MC68EN302

Errata and Added Information to

MC68EN302 Integrated Multiprotocol Processor with Ethernet Controller Reference Manual Rev 1

September 1, 1997

FIGURE 8-1B External Master DRAM READ CYCLE

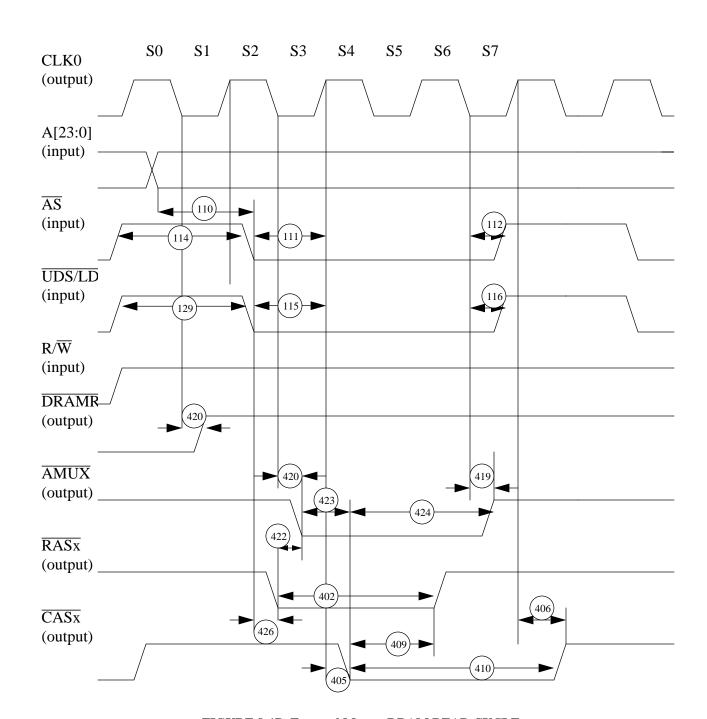
In Section 8.3, the following entries should be added (refer to Figures 8-1b and 8-2b):

NUM	Characteristic	20MHz		251	UNIT	
		Min	Max	Min	Max	
426	AS low to RASx low	-	25	-	20	ns
427	UDS (LDS) low to CASx low	-	22	-	18	ns

FIGURE 8-6 Ethernet Transmit Timing

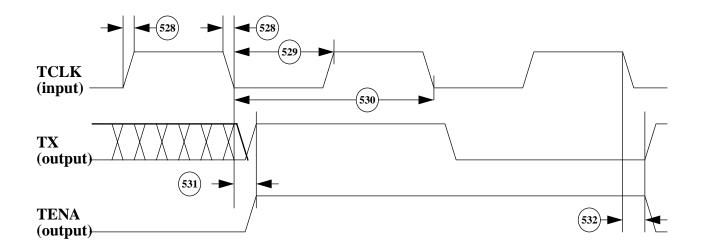
As a result of the changes in specs 531 and 532, Figure 8-6 changes to the following:

In Section 8.4, Table 8-2, the Ethernet Timing specs 531 and 532 should be changed to:

NUM	Characteristic	Min	Max	UNIT
531	TCLK low to TXD, TENA High Delay	0	15	ns
532	TCLK low to TXD, TENA Low Delay	0	15	ns
